Office Action Summary

10/615,408

DETAILED ACTION

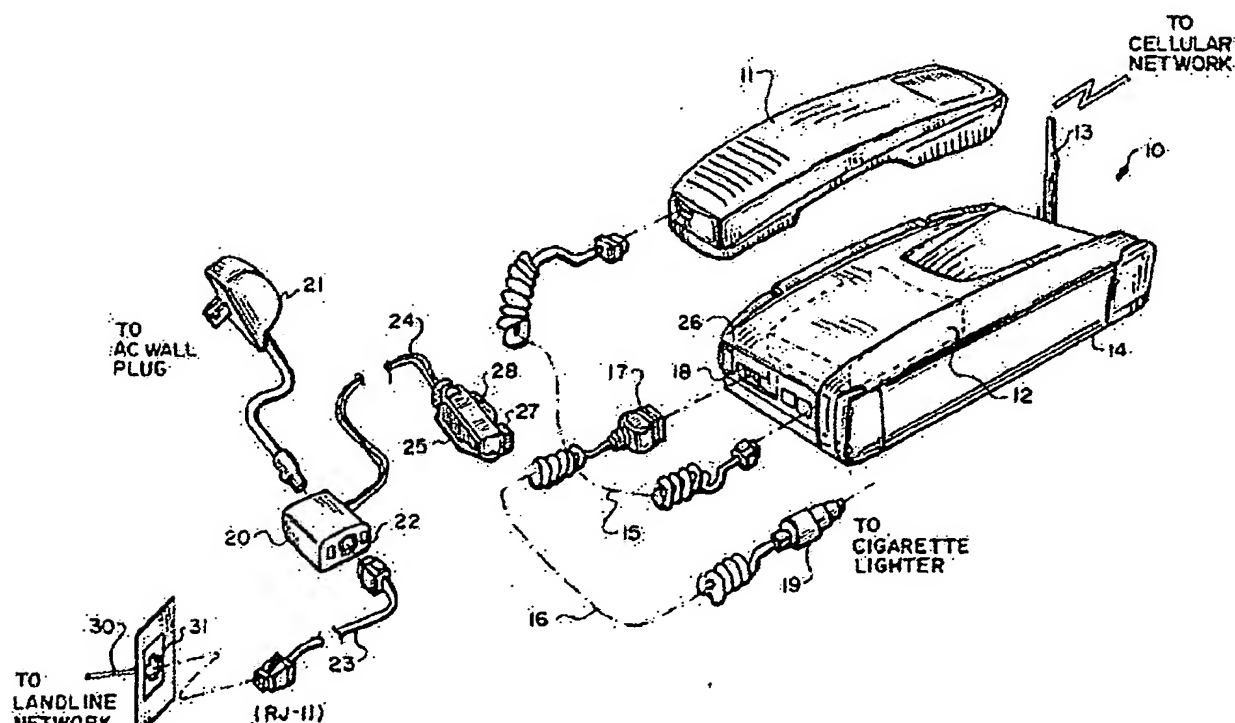
Tam discloses a communication system (figure 1) comprising a communication device (figure 3) and interface circuitry (figure 5) connected to a landline communication network (figure 4, #52) and comprising a wireless transceiver (#12) for communicating over a wireless communication link (#53) with a wireless communication device (#14) for a wireless communication network (#53), wherein the interface circuitry selectively connects the communication device to the landline communication network (#52) for landline calls and to the wireless communication device (#10) via the wireless communication link (#53) for wireless calls.

Tam shows the interface circuitry comprises a first switch (#235) connected between the communication device (#14) and the ring-tip line pair (#301, 30, 302). A second switch (#123) connected between the communication device and the wireless communication device (#14) and a processing circuit (#124, 24-3, 127) for controlling the first (#235) and second switches (#123).
